REQUEST FOR COUNCIL ACTION

AGENDA SECTION: PUBLIC HEARING	ORIGINATING DEPT: PLANNING	ITEM NO. E-11
ITEM DESCRIPTION: Final Plat #02-33 by Arcon Development Inc. to be known as Crimson Ridge. The Plat proposes to subdivide approximately 78.72 acres of land into 81 lots for single family detached housing and 7 outlots for future single family attached housing. The plat also dedicates the right of way for new public roadways. The property is located along the west side of 18 th Ave. NW, north of the Volunteers of America Development and Hunter Hills and east of 24 th Ave. NW.		PREPARED BY: Brent Svenby, Planner

RE: Final Plat #02-33 to be known as Crimson Ridge Subdivision

SHEET NO. 3 OF 3

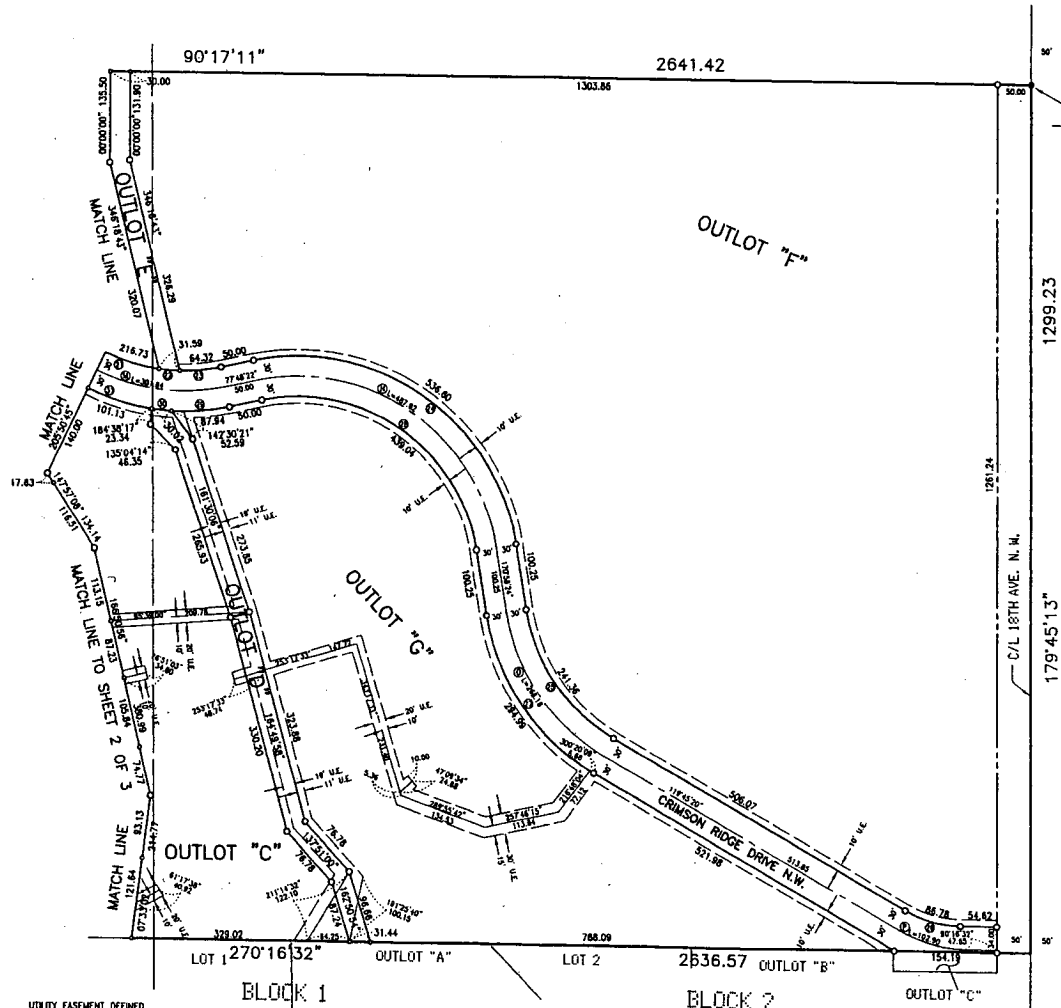
1. The short stretch of roadway between Mountain Ash Lane NW and the western edge of plat needs to be given a designation.

RECOMMENDATION: Designate this short stretch of roadway as **60 STREET NW**.
